DART SERVICE INSTRUCTION

TO AMEND INSTALLATION INSTRUCTIONS D350-607-3 Rev.D,

REF TCCA STC: SH94-14

A	NEW ISSUE	AJS	14.05.16
REV.	DESCRIPTION	BY	DATE
DESIGN	AJS	DART AEROSPACE LTD HAWKESBURY, ONTARIO, CANADA	
DRAWN	AJS		
CHECKED	N/A	DRAWING NO.	REV. A
MFG. APPR.	N/A	DSI 9699	SHEET 1 OF 2
APPROVED		TITLE	SCALE
DE APPR.		LUG REPLACEMENT	NTS
DATE	14.05.16	COPYRIGHT © 2014 BY DART AEROSPACE LTD THIS DOCUMENT IS PRIVATE AND CONFIDENTIAL AND IS SUPPLIED ON THE EXPRESS CONDITION THAT IT IS NOT TO BE USED FOR ANY PURPOSE OR COPIED OR COMMUNICATED TO ANY OTHER PERSON WITHOUT WRITTEN PERMISSION FROM DART AEROSPACE LTD.

FIGURE 1: INSTALLATION OF D4775-041 FWD STRUT

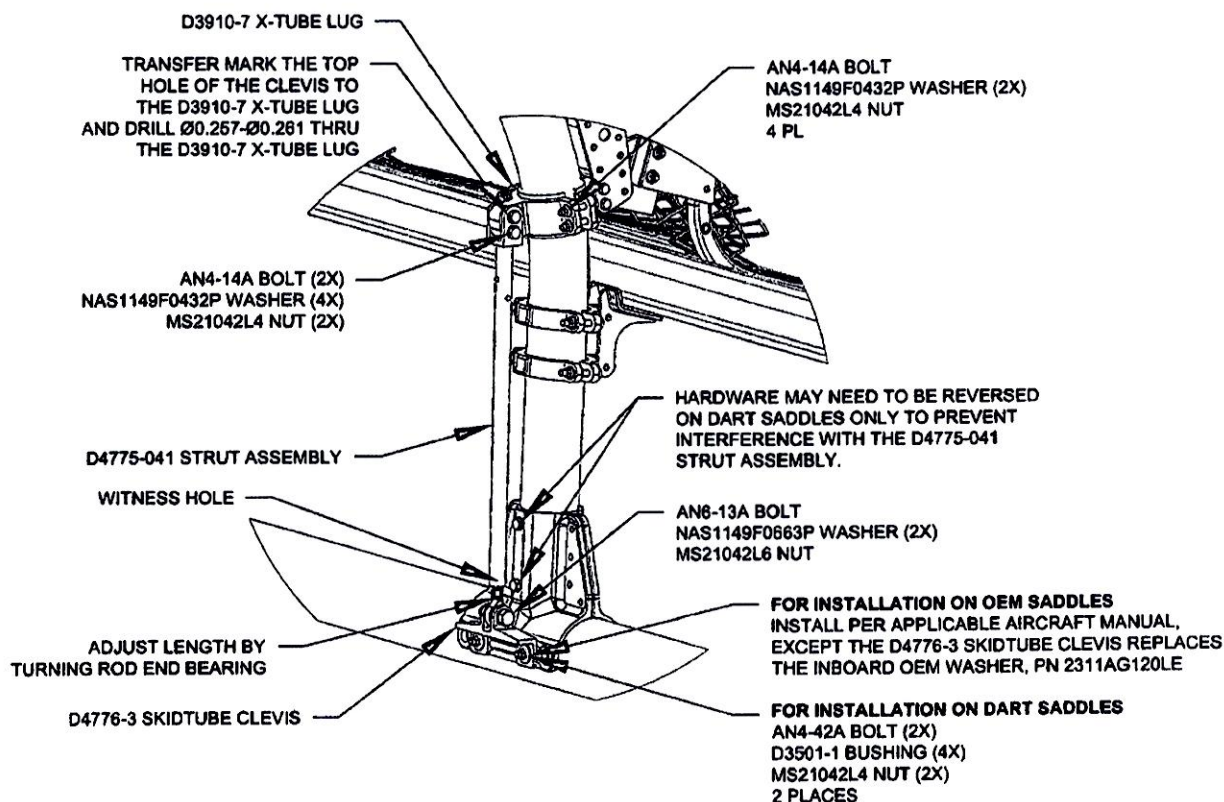
3.1 Substitute the Forward Lower D3910-5 X-Tube Lug with the D3910-7 X-Tube Lug as shown in Figure 1.

3.2 Install the forward D4775-041 Strut Assembly. Transfer mark from the upper hole on the clevis of the D4775-041 Strut Assembly to the D3910-7 X-tube Lug and drill thru the lug $\varnothing 0.257$ - $\varnothing 0.261$ as shown in Figure 1. Touch up chemical conversion coating per MIL-DTL-5541. Check the witness holes located at the bottom end of the D4775-041 Strut Assemblies to ensure that the thread from the rod end extends past the witness hole.
Torque MS21042L4/-4 nuts to 50-70 in-lbs (5.7-7.9 N-m). Torque MS21042L6/-6 nuts to 160-190 in-lbs (18.1-21.5 N-m).
